भारत सरकार Government of India
रेल मंत्रालय Ministry of Railways
रेलवे बोर्ड Railway Board

No.96/M(C)/141/77

Sub: Committee report on Standardization of Enroute Carriage Watering System.

GENERAL LAYOUT OF PROPOSED ENROUTE CARRIAGE WATERING SYSTEM

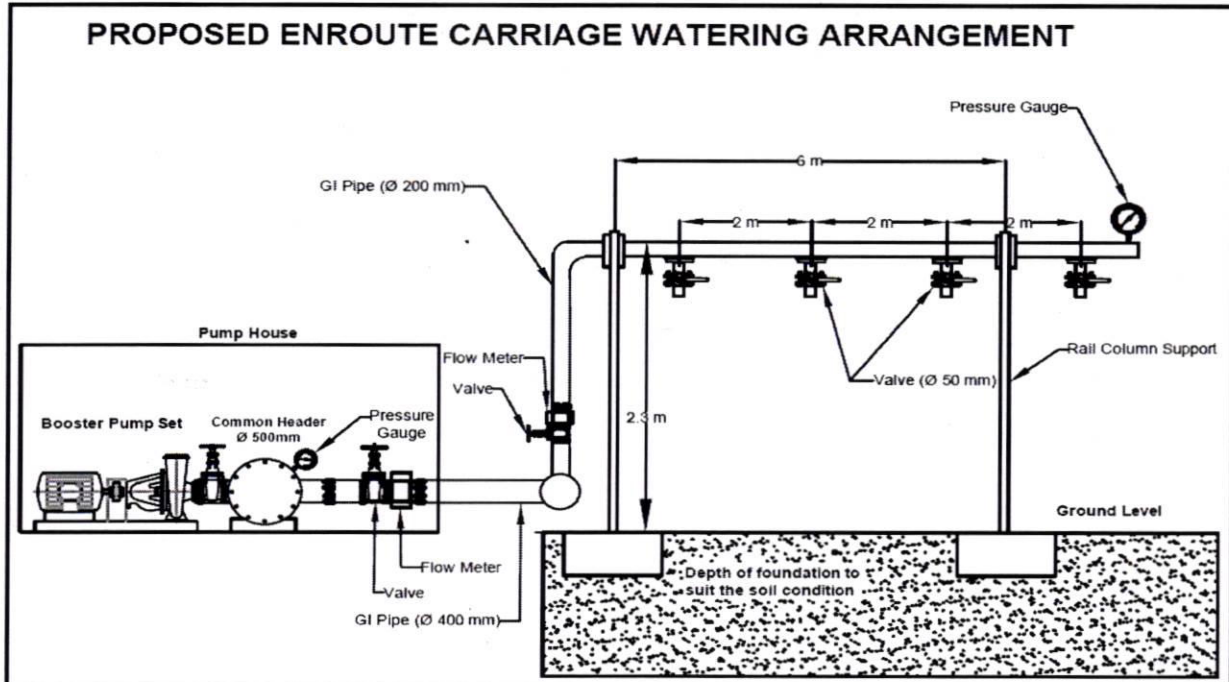
- 2) The proposed watering system is suitable for two watering lines, in case there are more watering lines then the additional parallel set of watering systems is to be installed. All sets of pumps should be interconnected through the header so that in case of failure of one pump set another pump set will feed the water supply.
- 3) A proper pathway of one meter width for ease of carriage watering is to be provided as recommended in the earlier report of 2008. It is seen that most stations do not have proper pathways which is a dangerous situation and needs to be addressed. All new station development projects across IR should address this issue.

- 4) Proper illumination over the pathway is to be provided for rake filling in night time.
- 5) A DG set of 250 kVA rating capacity for one set of booster pumps, i.e. 3 pumps together, to be installed. If more pumps are installed, then capacity of DG set may be evaluated.
- 6) Water reservoirs used for coach watering is to be separated and not to
